Re Indian Point Unit No. 2
Docket No. 50-247

In order to increase spent fuel storage capacity of Indian Point Unit No. 2, Con Edison plans to replace the present storage racks with racks of a modified design. The new design provides a closer spacing of spent fuel assemblies so there will be almost twice as many storage locations as at present.

INDIAN POINT UNIT NO. 2 - FUEL POOL MODIFICATION

FIGURE 1

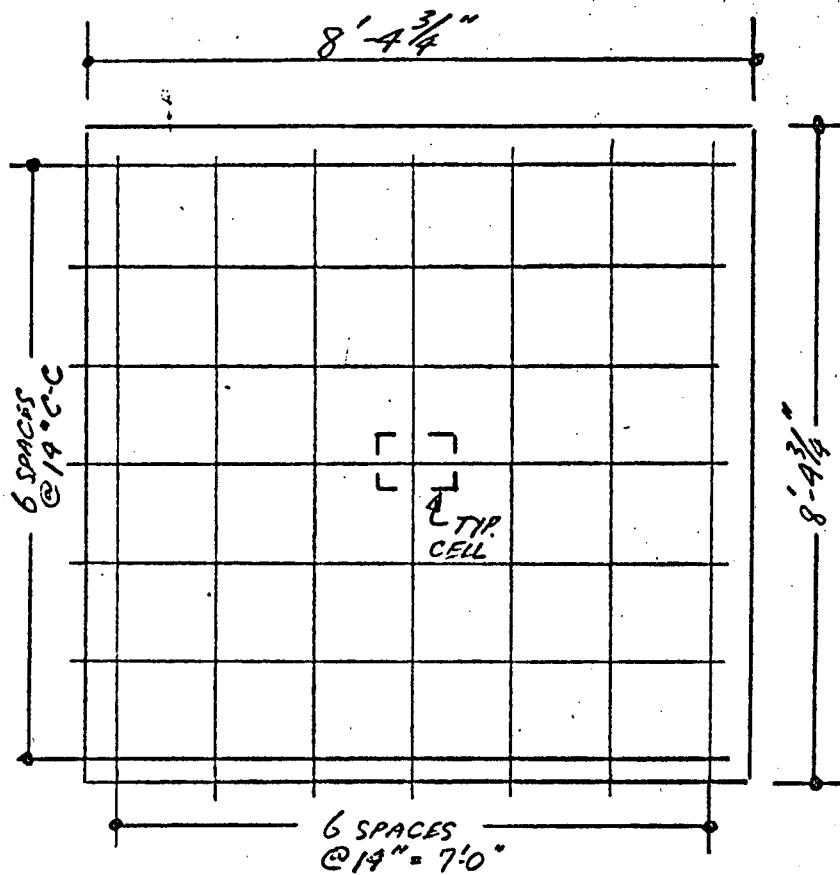
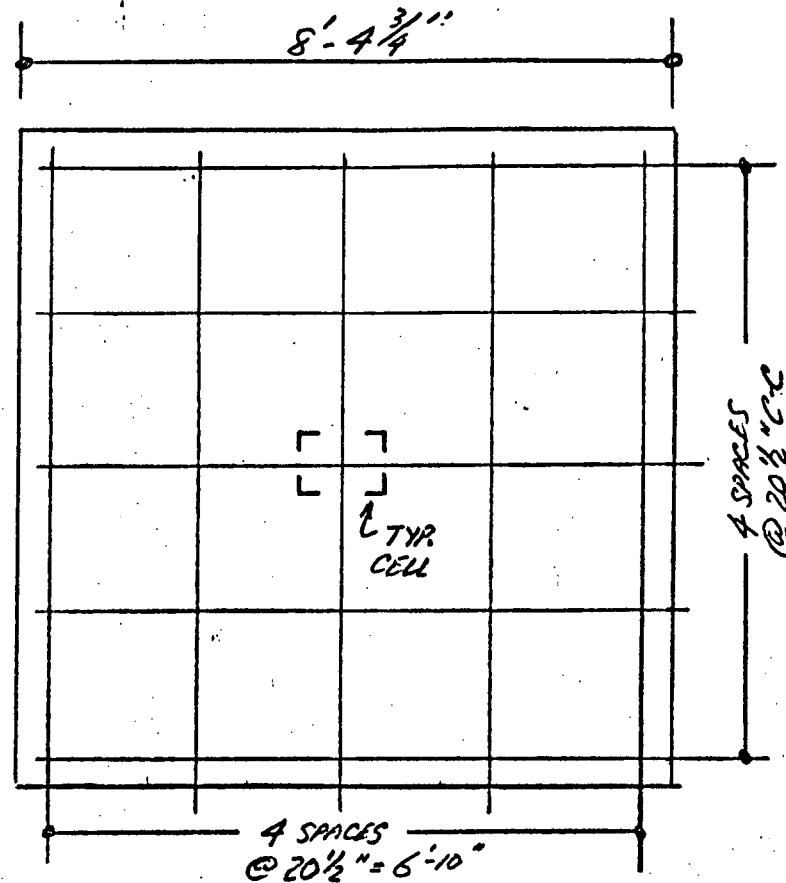
- a. The center-to-center spacing of the storage locations is reduced from the present 20.5 inches to 14 inches.
- b. To insure subcriticality with the reduced spacing, every storage location will have a seven inch wide, 1/8 inch thick boron-stainless steel plate on each of the four sides. The plates will run the full length of the active fuel region of an assembly and will be welded to the stainless steel angles that form the storage location.

These changes, shown in Figures 1 and 2, will permit nearly twice as many fuel assemblies to be stored in the same space.
